4. Mine Site Water Management and Water Storage Facility

4.1 SITE AND DEVELOPMENT DESCRIPTION

Figure 5.1-1

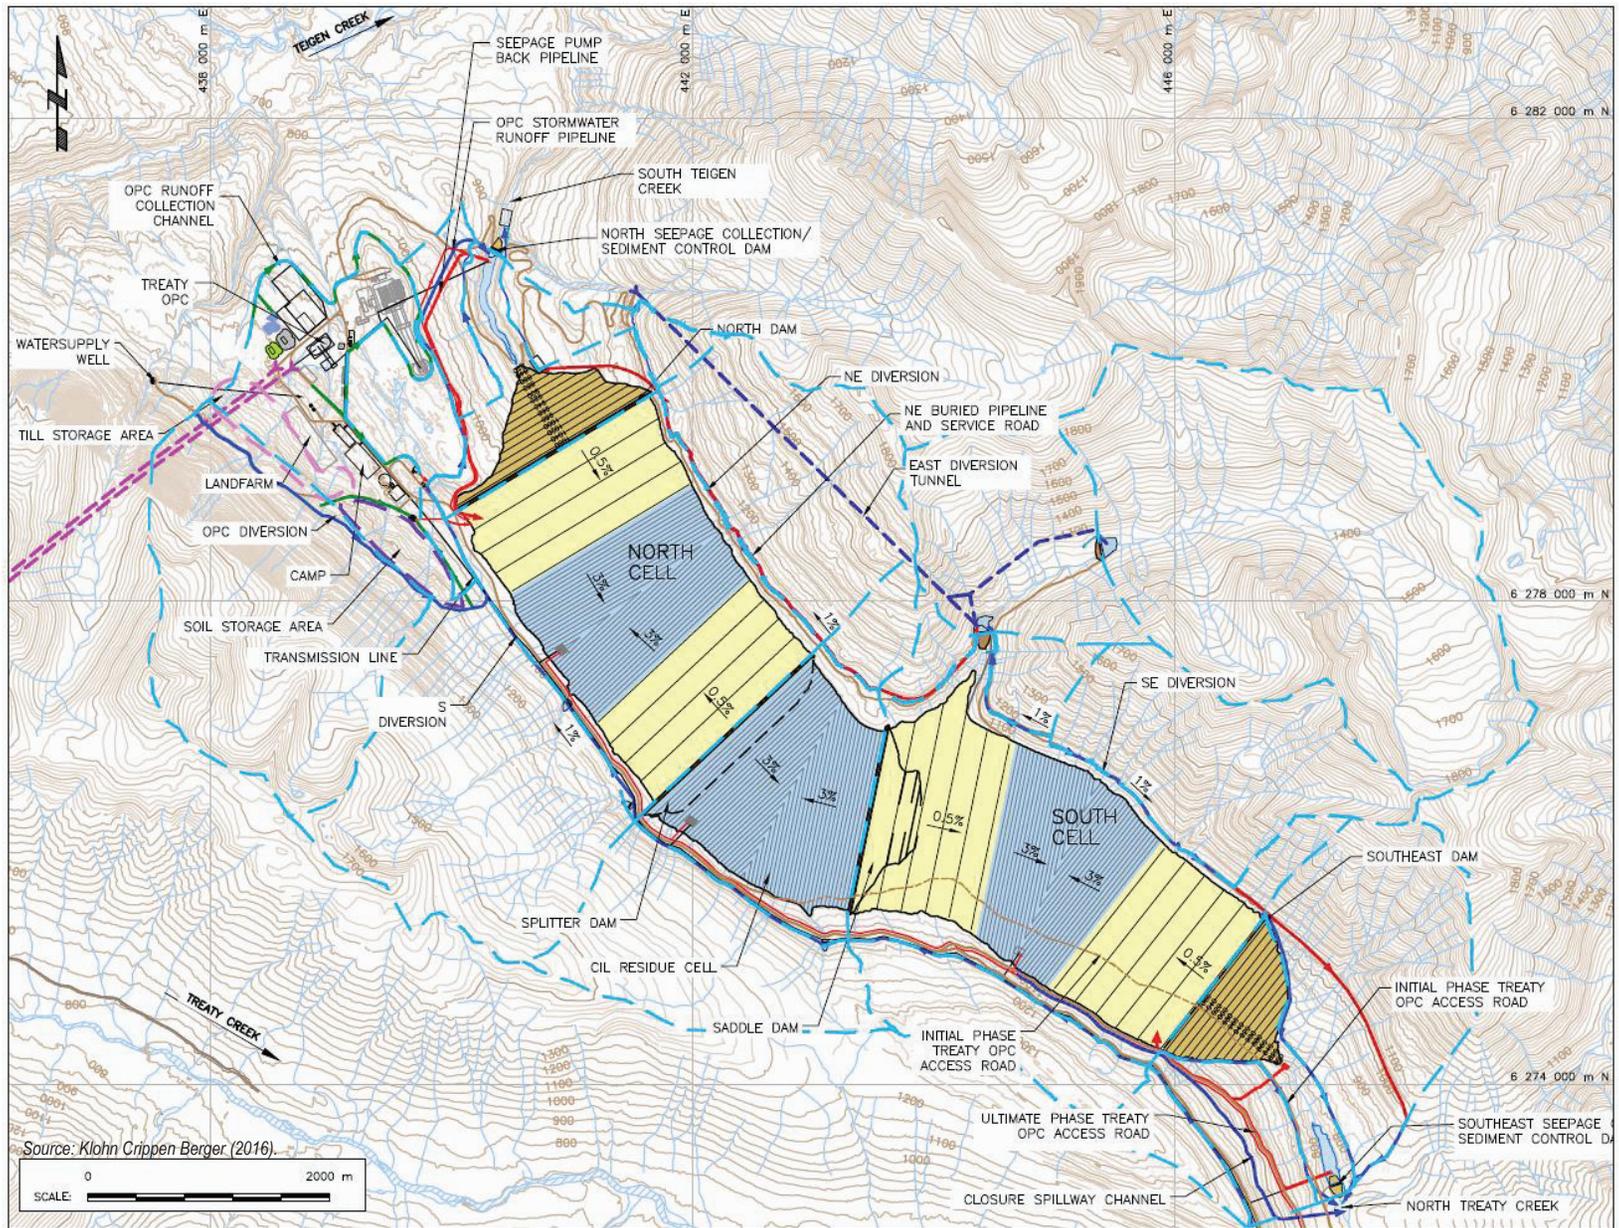
The northern part of the TMF site is drained to the north by a tributary to Teigen Creek, which in turn drains into the Bell-Irving River (Figure 5.1-1). The southern part of the TMF site is drained to the south into Treaty Creek and from there also into the Bell-Irving River. Surface elevation at the Site ranges from 800 m to approximately 1,800 m. The East Creek tributary drains from the north-east into the central portion of the TMF site. Glaciers occur in the upper headwaters of East Creek.
